## **Staff Report to the Zoning Administrator**

**Application Number: 211316**

**Applicant:** Matson Britton Architects  
**Owner:** Mary Lacerte and Kirk Kozlowski  
**APN:** 043-081-13  
**Site Address:** 266 Cliff Ct, Aptos

**Project Description:** Proposal to construct an approximately 110 linear foot pin pier retaining wall, on-site with an existing single-family dwelling.

PIN PIER WALL & CONCRETE LAGGING  
NTS

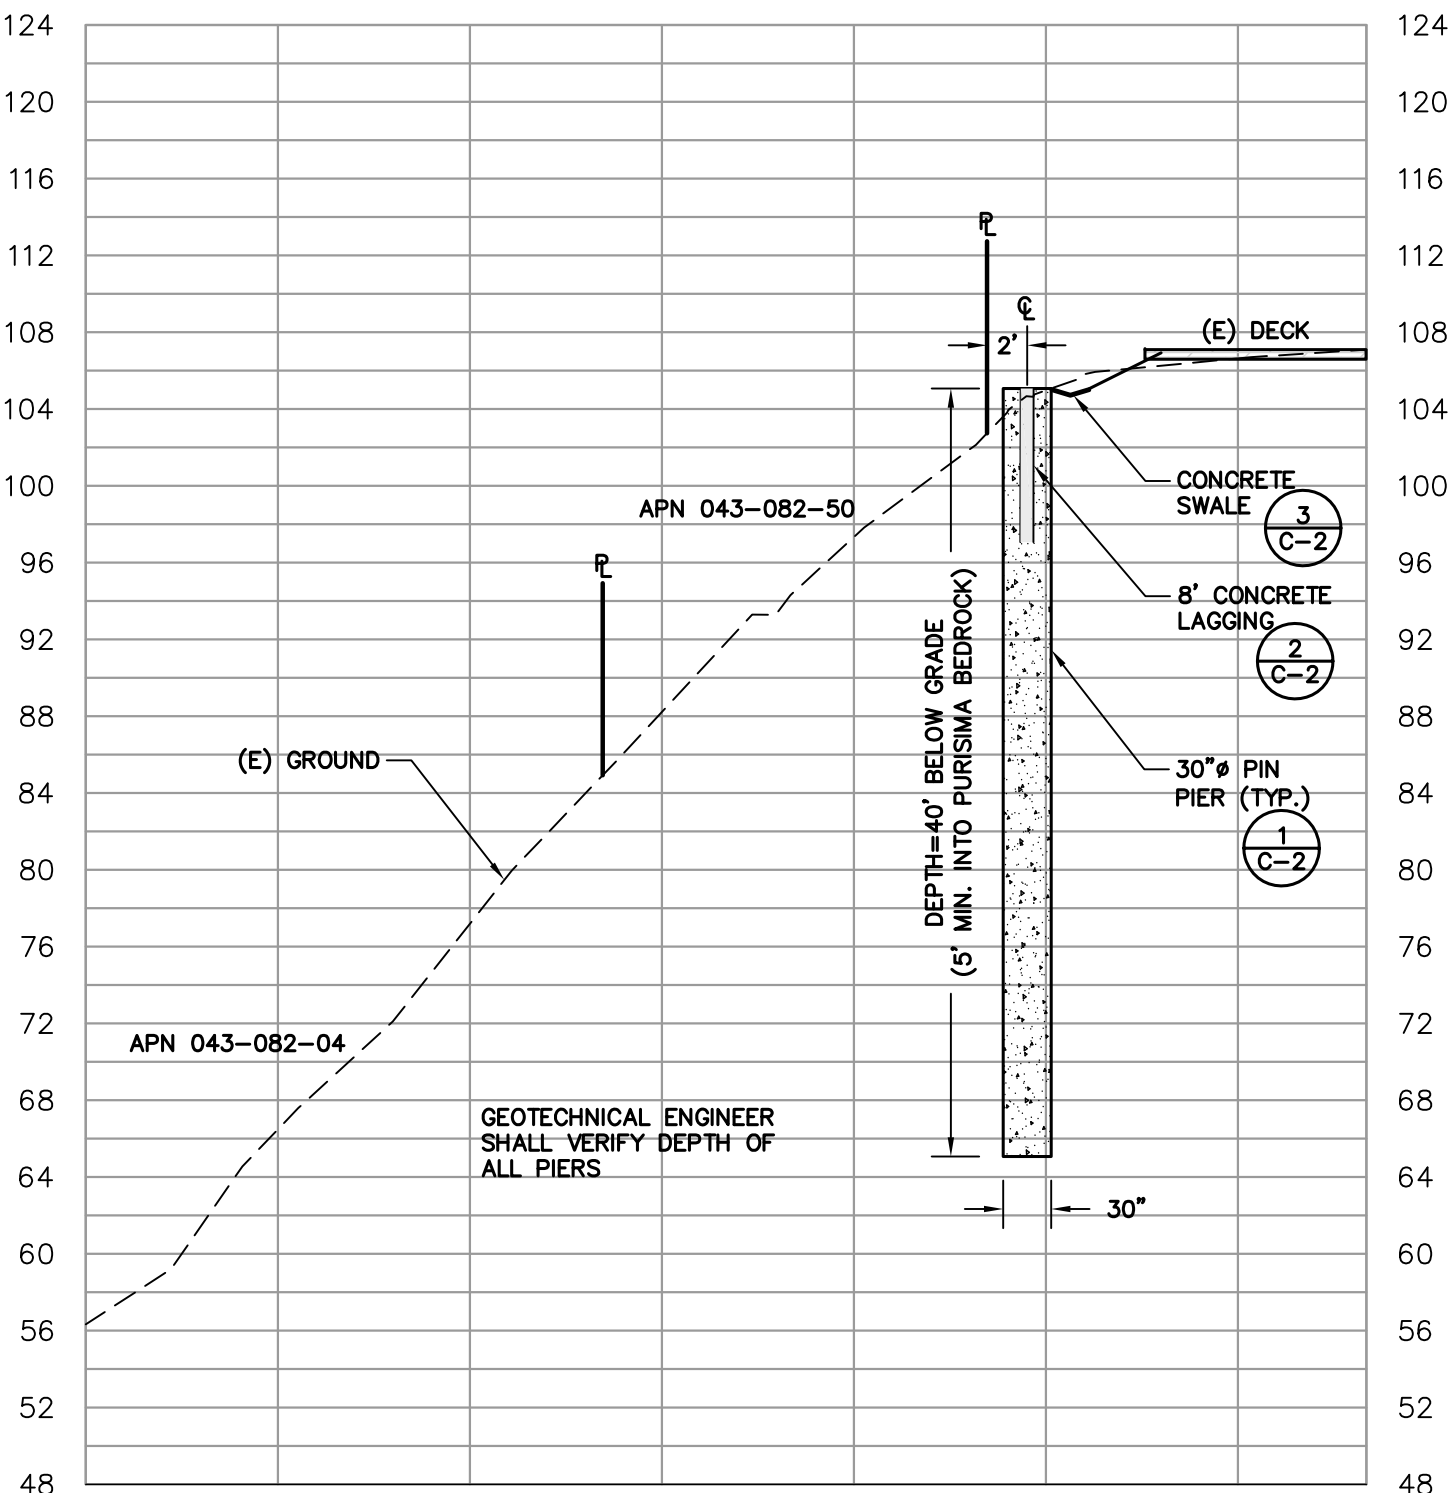
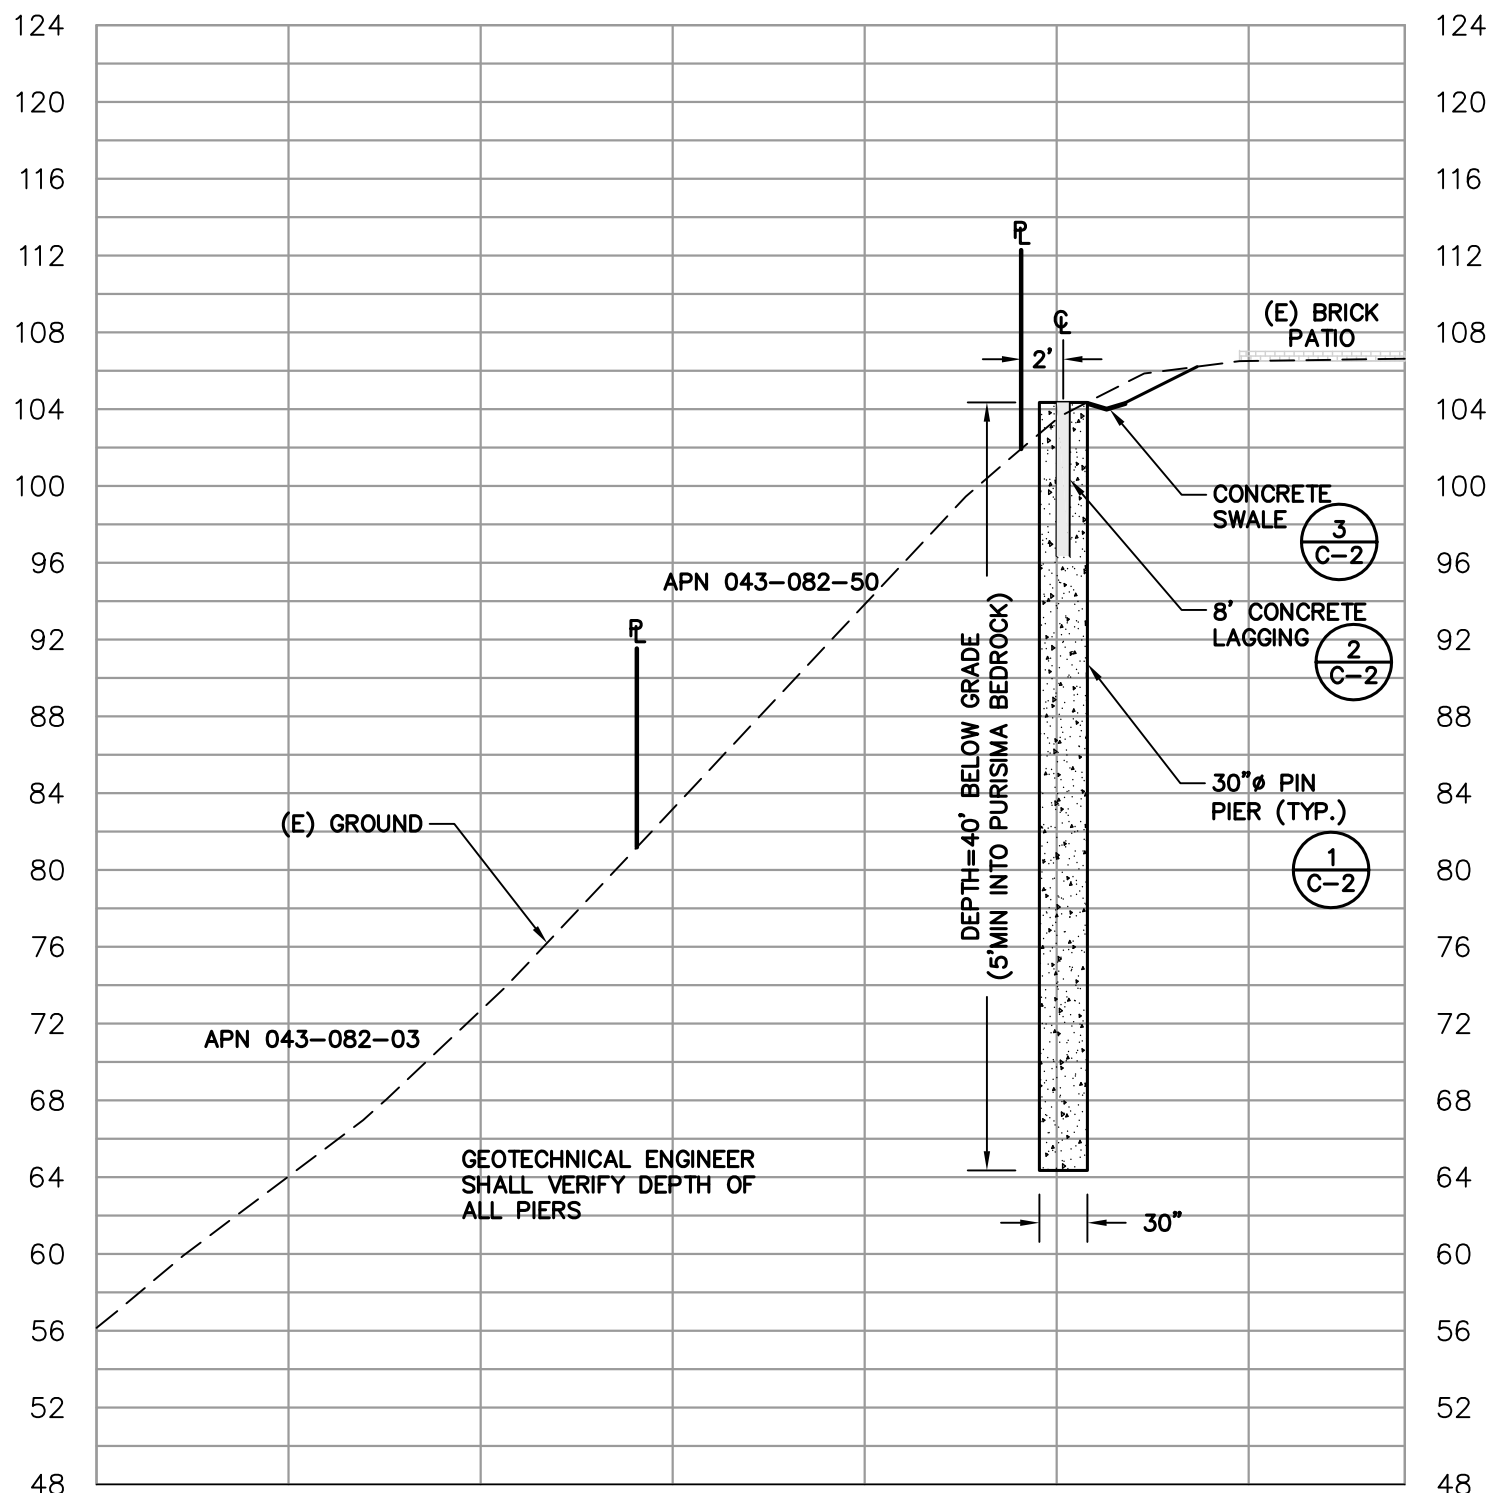
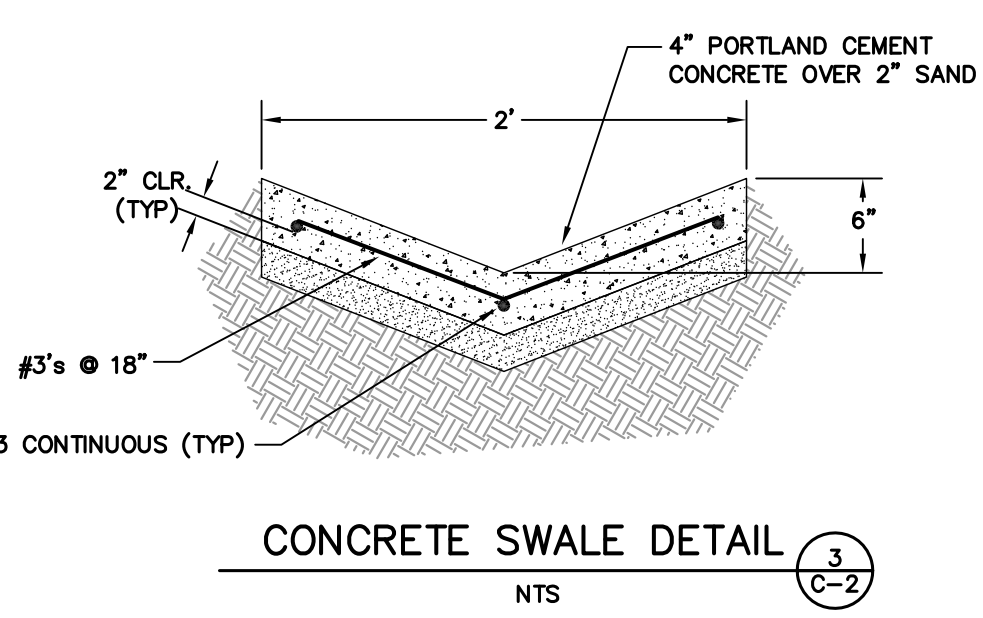
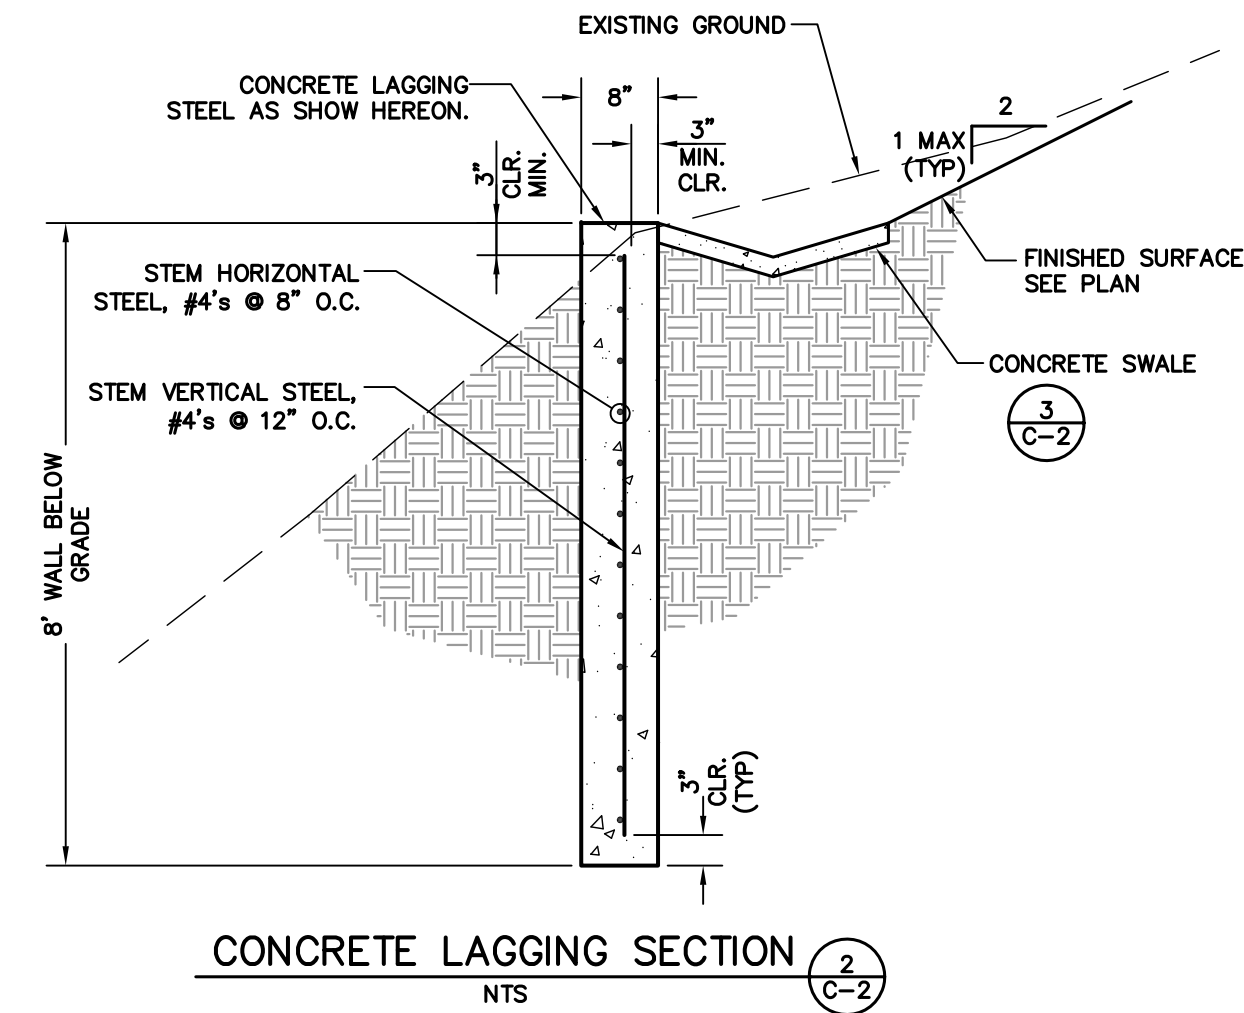
- Comment: Both adjacent parcels are not similarly protected, therefore the project does not comply with this section of County Code.
- (b) Seawalls, specifically, shall only be considered where there is a significant threat to an existing structure and both adjacent parcels are already similarly protected.

- Comment: The Geologic and Geotechnical Reports do not state that there is a significant threat to the existing structure and that the proposed retaining wall is a “soil retention system”, therefore the project does not comply with this section of County Code.

- Comment: An alternatives analysis has not been provided which demonstrates all reasonable alternative to the proposed retaining wall, therefore the project does not comply with this section of County Code.

- Comment: As stated above the existing structure has not been determined to require protection, therefore the project does not comply with this section of County Code.
- Public Works Stormwater Management (Alyson Tom- 831-454-2364):
